Centennial Trail – Summit Blvd

Design Review Board

Collaborative Workshop Meeting April 8, 2020

DRB Project Number: 2004

SITE CONTEXT

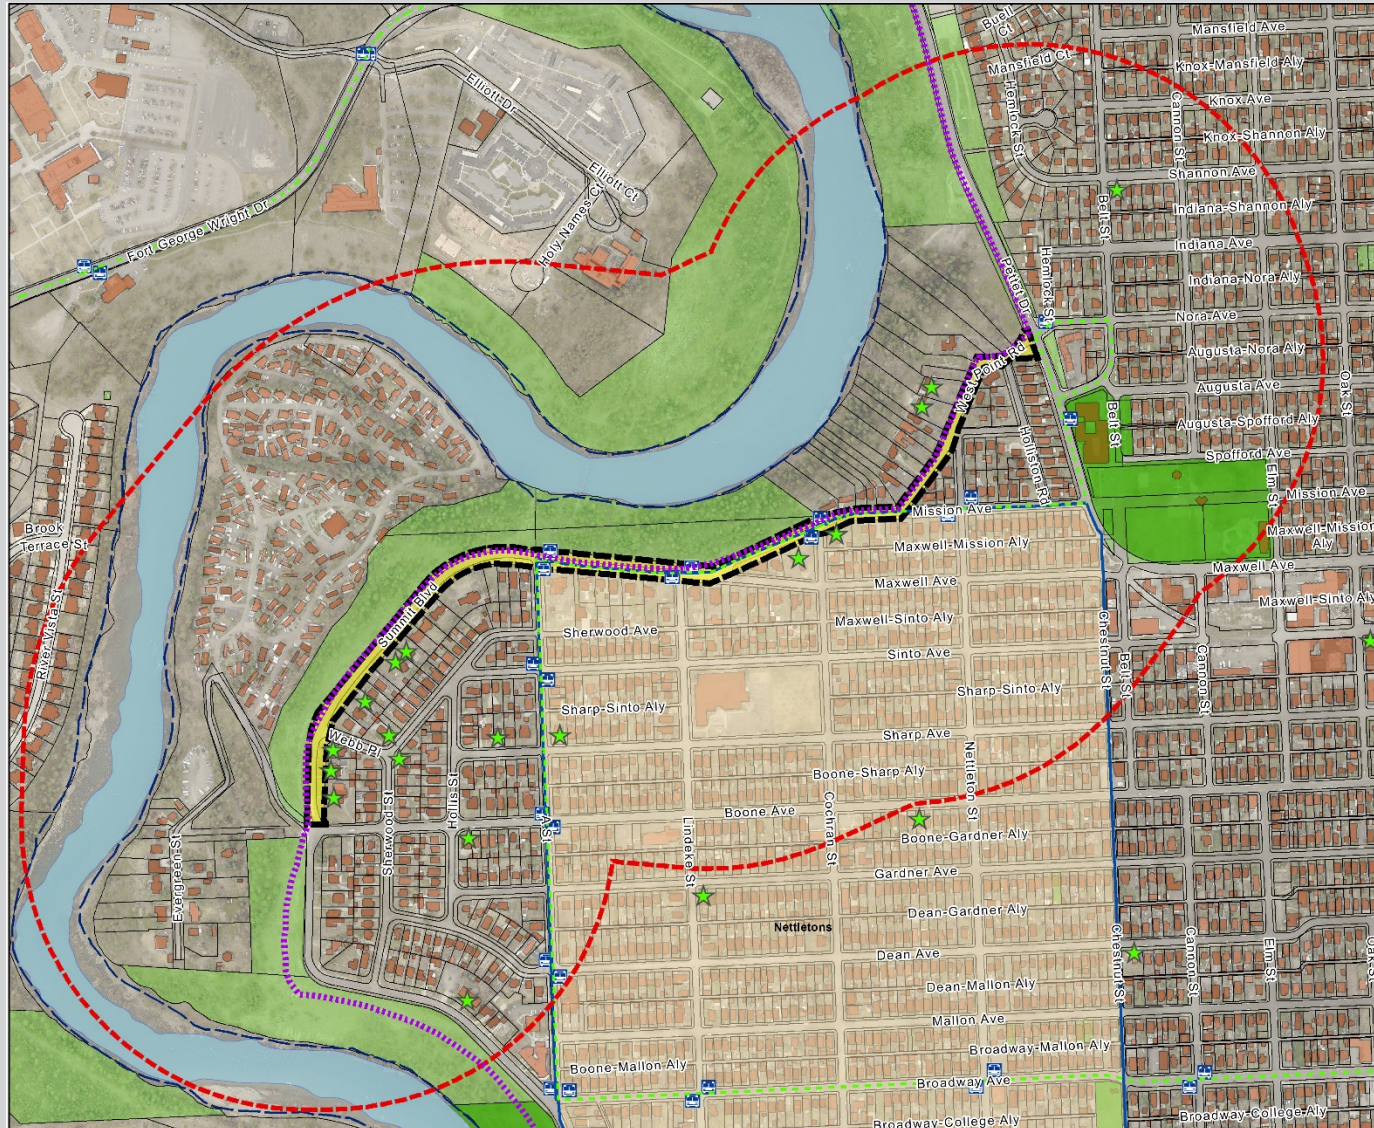
Is there an opportunity to better integrate the topography of the existing site along portions of Summit Boulevard to reduce the extent of the two-pipe railing system, while reducing the presence of retention walls?

(For example, via the elimination of on-street parking, keeping two-way traffic, while moving the proposed 10'-wide Path 8 feet further away from the adjacent steep grade)
